## Rear Wheel Bearing Noise

### PROBABLE CAUSE

The rear bearing hub caps were not manufactured correctly, allowing water to leak into the hub bearing assemblies, and contaminating the bearings.

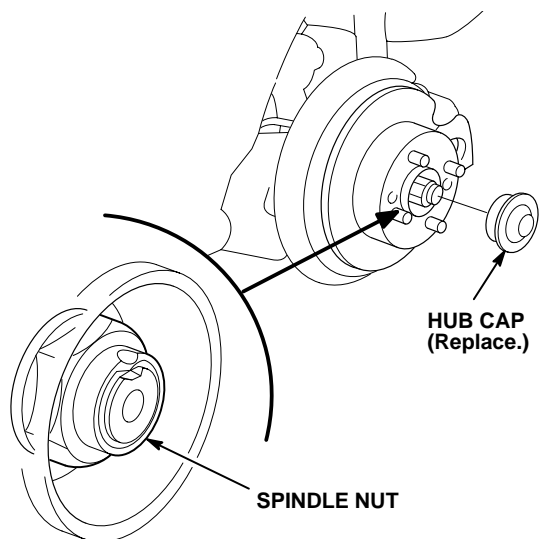
1. Determine which rear hub bearing assembly has failed, and replace it with the correct one listed under PARTS INFORMATION. Refer to section 18 of the appropriate service manual for instructions.

2. Install a new spindle nut, and tighten it to the correct torque specification. Use a drift to stake the spindle nut shoulder against the spindle.

3. Install new bearing hub caps on both sides.  
**NOTE:** Both bearing caps must be replaced; otherwise the bearings may fail again in the future.
